MEMORANDUM

Re: Department of Environmental Quality, Land Quality Division
MCC Permit 296C-A7, TFN 5/110

Meeting: Points coming out of meeting dated January 2, 2014, with the following participants:

Mountain Cement Company Exhibits
EQC Docket No. 13-407
LQD Permit No. 298C-A7; TFN 5 1/110
MCC-4

Figure E-1. Raptor nests observed and previously reported on the site and in the vicinity. Those nest sites in blue are no longer present while those in red were present as of 2009.

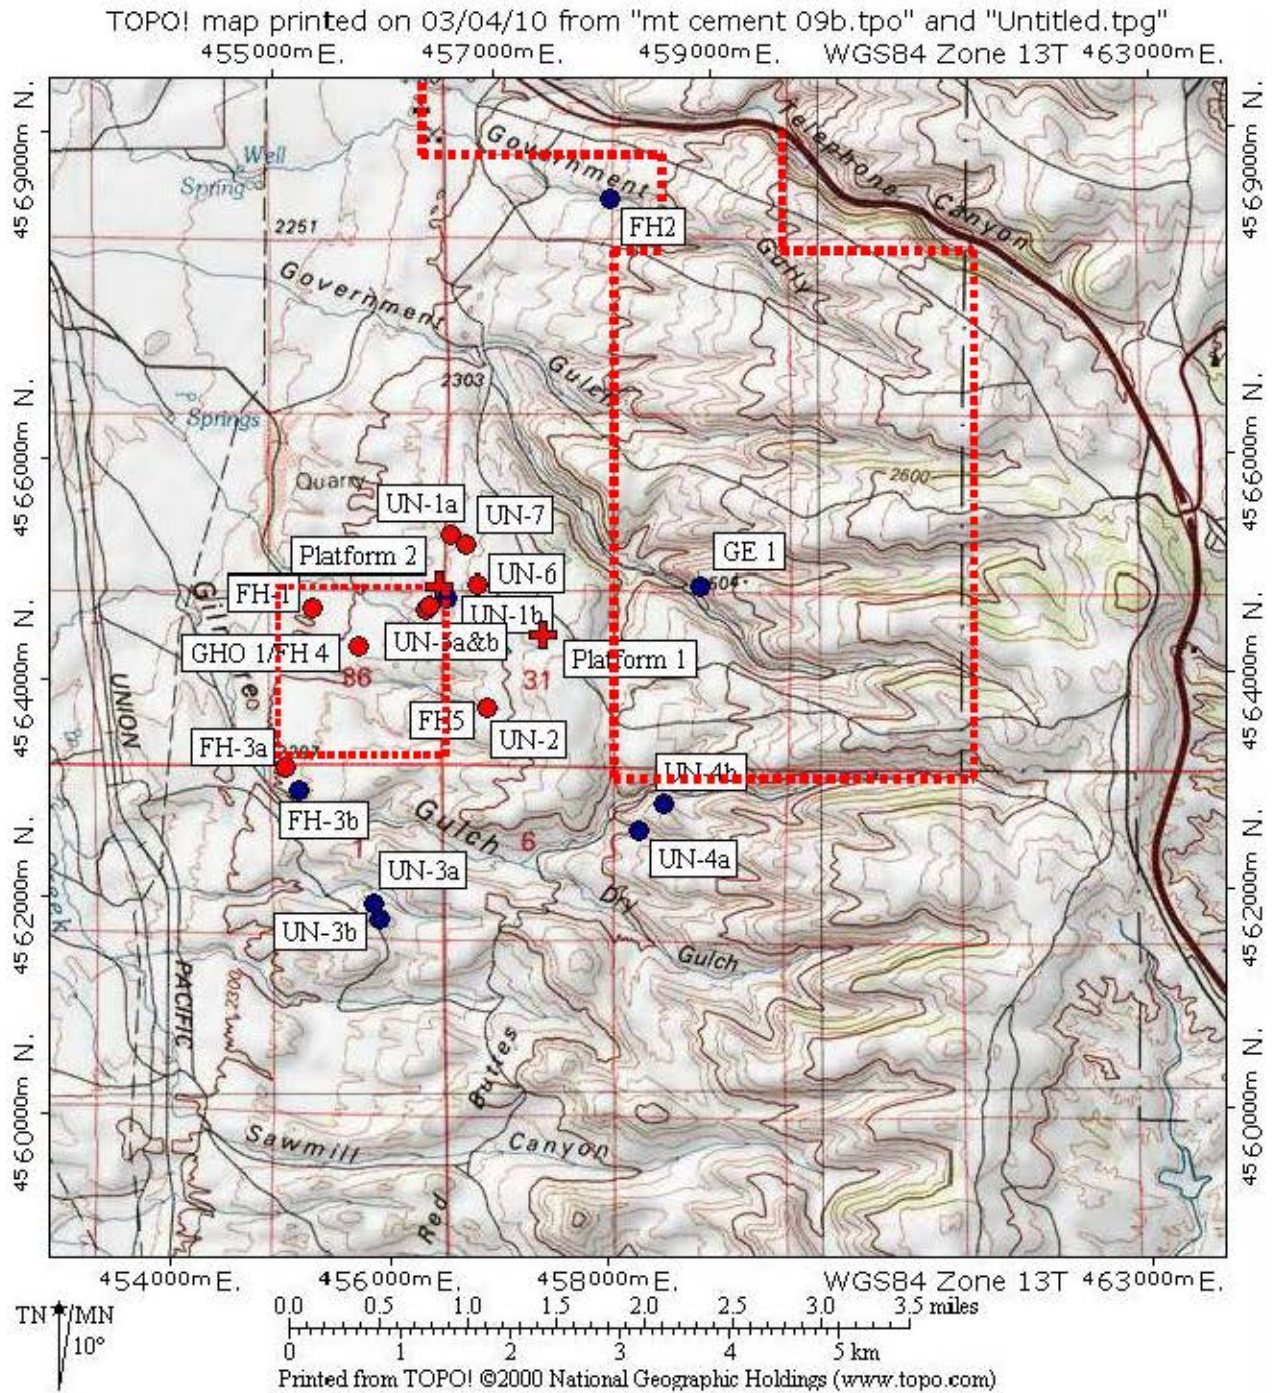
Issue: The last page of the section, Page DIX9-63 provides a quad map with apparent nesting sites. There are site with red and blue dots. The map does not have a key. Presumably, the blue dots were sites that were not located and the red dots are confirmed nests.

Solution: Attached as Exhibit D is a modified map with a key.
